PICDEM.net Demonstration Kit Errata Sheet

The PICDEM.net Demonstration Kit you have received conforms functionally to the information provided in its accompanying User's Guide (DS39563B), except for the anomalies described below.

FIGURE 1: LOCATION FOR RESISTOR INSTALLATION

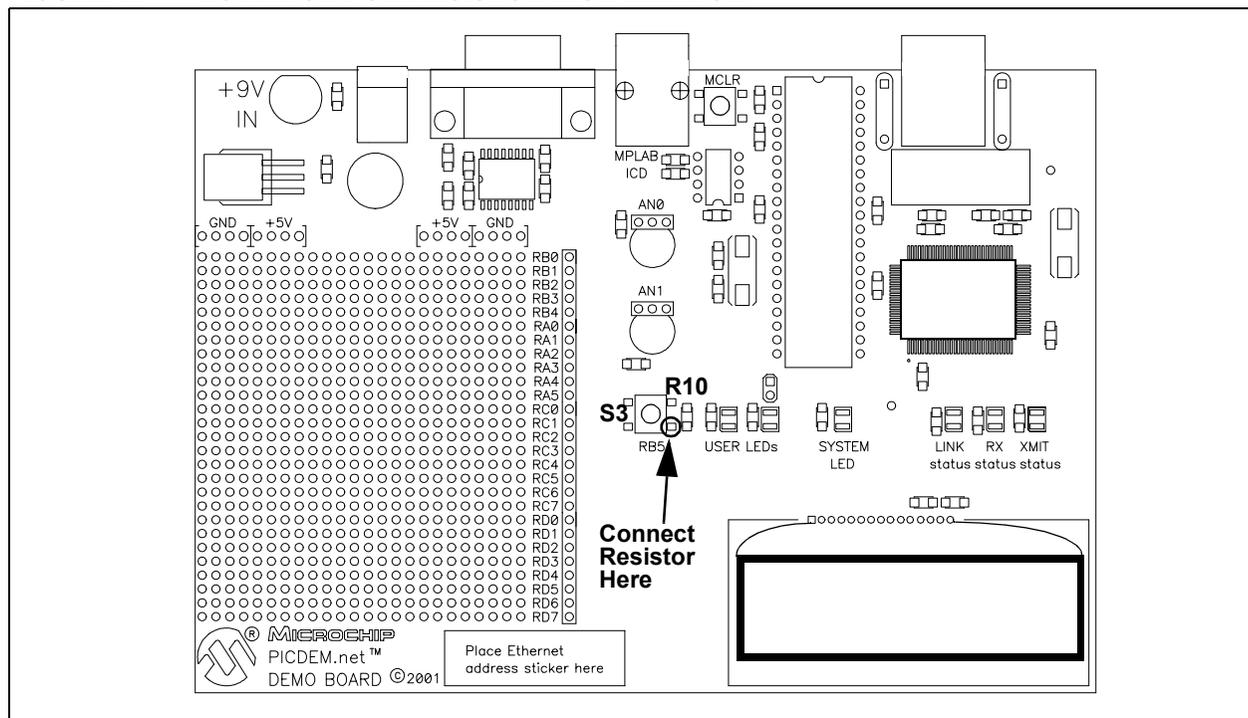
Symptom: While attempting to reprogram an installed microcontroller using the Microchip MPLAB® ICD 2 In-Circuit Debugger, the user may encounter occasional programming failures.

This has only been observed when the installed microcontroller is a 40-pin PIC18F device.

Problem: All of Microchip's PIC18F microcontrollers offer In-Circuit Serial Programming™ (ICSP™), which uses a Low Voltage Programming mode. By default, this mode is enabled and can be entered by pulling RB5 low. Since the PICDEM.net board was originally designed with the PIC16F877

microcontroller in mind (which does not offer the low voltage option), an explicit pull-up on RB5 was not included. Adding a pull-up resistor when using PIC18F devices prevents the microcontroller from accidentally entering Low Voltage Programming mode.

Solution: Install a 10 kΩ resistor between the junction of R10 and push button switch S3, and the +5V supply. This will ensure that RB5 is pulled high.

The simplest way to do this is to connect one end of the new resistor directly to the terminal of push button S3 (labelled "RB5") on the board, and the other side to a convenient +5 VDC source. The terminal is indicated in Figure 1.

The resistor is only necessary for PIC18F microcontrollers. If you are also experimenting with PIC16 FLASH devices, the resistor may be left in place without adverse effect. It only needs to be removed if the logic of your application dictates it.
